Memorandum

Subject: INFORMATION: Equivalent Level of Safety (ELOS) Finding for Installing Rockwell Collins, Inc., Powerplant Engine Instrument Display on Beechcraft, Model King Air C90GTi Airplane, Project #: ST05938W1-A

ELOS Memo#: ACE-15-18

Figure 1 – Pro Line Fusion[®] Integrated Avionics System Display

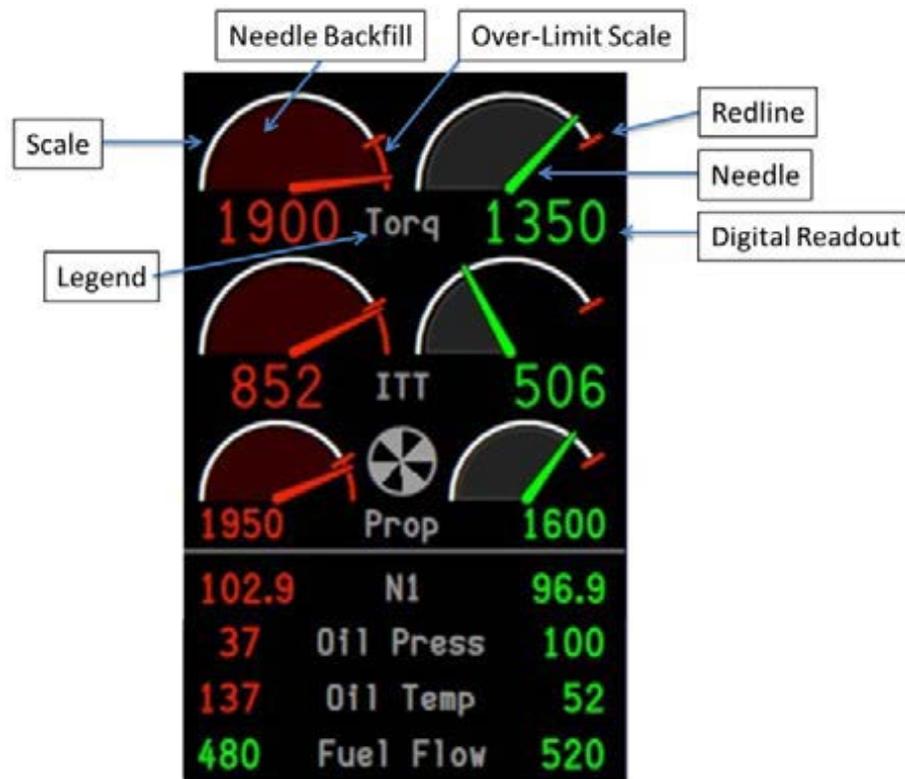
The Pro Line Fusion[®] primary engine indication only displays digits to indicate N1 gas generator speed as shown in figure 1. Section 23.1305 (c)(5) requires an indicator to display rotor speed.

Section 23.1549(a),(b), and (c), amendment 23-45, require green, yellow, and red markings on the instruments to denote the normal, precautionary, and maximum safe regions of operation. It is not practical to mark the required maximum or minimum values with required radials or lines on a digital-only indicator. The compensating features of this indicator are that—

The Pro Line Fusion[®] primary engine indication only displays digits to indicate the oil temperature and pressure as shown in figure 1. Section 23.1305 (a)(2) and (a)(3) requires an indicator. Section 23.1549(a),(b), and (c), amendment 23-45 requires green, yellow, and red markings on the instruments to denote the normal, cautionary, and warning regions of operation. It is not practical to mark the required maximum or minimum values with required radials or lines on a digital-only indicator. The compensating features of this indicator are that oil temperature and pressure are not controlled by the flight crew. Oil temperature changes do not typically occur so rapidly that required flightcrew action is necessary to prevent a limit exceedence. Oil pressure can rapidly change, but low oil pressure is the only region requiring flight crew action. A red crew-alerting system (CAS) message, with accompanying master chime and aural tone, is displayed to the crew to increase awareness.

The Pro Line Fusion[®] primary engine indication has digits only to indicate Fuel Flow (FF), these digits will always be green as shown in Figure 1. Section 23.1305 (c)(2) requires an indicator. Section 23.1549(a),(b), and (c), amendment 23-45, require green, yellow, and red markings on the instruments to denote the normal, cautionary, and warning regions of operation. It is not practical to mark the required maximum or minimum values with required radials or lines on a digital-only indicator. However, there are no maximum and minimum values for fuel flow. The compensating feature of this indicator is that there are no limits for fuel flow. With no limits, there is no need to assess rate of change or exceedence.

- (1) The digits are displayed in color when a caution (yellow) or warning (red) value is reached, clearly indicating when the operating value is at or exceeding the maximum or minimum limit;
- (2) The digits will be green in the normal operating range and a redundant N1 overspeed protection system is provided mitigating need for flightcrew action to prevent exceeding part 33 limits.

The flight crew indirectly controls N1 speed. The flight crew uses propeller rpm and torque to set power. N1 speed will vary depending on ambient conditions, power extraction, engine condition etc. While N1 speed can change rapidly, trend information is not used to manage the engine. Limit exceedances ensure safe engine operation at normal power settings. A mechanical flyweight governor and mechanical stop, included in the engine design, prevents N1 overspeed without flight crew intervention. Should the control system fail and N1 rotor speed exceed its allowable limits, the N1 digital indication, which changes color to warn the flight crew if any limit is exceeded, along with an aural indication provides an equivalent level of safety to the required indicator.

Oil temperature and pressure are not directly controlled by the flight crew. A device within the oil system, independent of any flight crew action, regulates the oil pressure. A thermostat within the oil system regulates oil temperature. Oil pressure and oil temperature do not typically change rapidly. Rapid action by the flight crew is not required to prevent exceeding a limit. The oil pressure and temperature digital indication color changes warn the crew if any limit is exceeded. Variable limits based on engine operating condition are programmed into the system to reduce the need for multiple marking on a single indicator. These features provide an equivalent level of safety to the required indicators.

Engine fuel flow for the C90GTi does not have limits and does not indicate engine power or condition. As there are no fuel flow limits, there is no need to assess rapid rates of change to prevent an exceedance. Therefore, the Pro Line Fusion[®] system fuel flow digits will always be green. Thus with no reason to monitor fuel flow to assure proper engine operation, the digital fuel flow indicator provides an equivalent level of safety to the required fuel flow indicator.
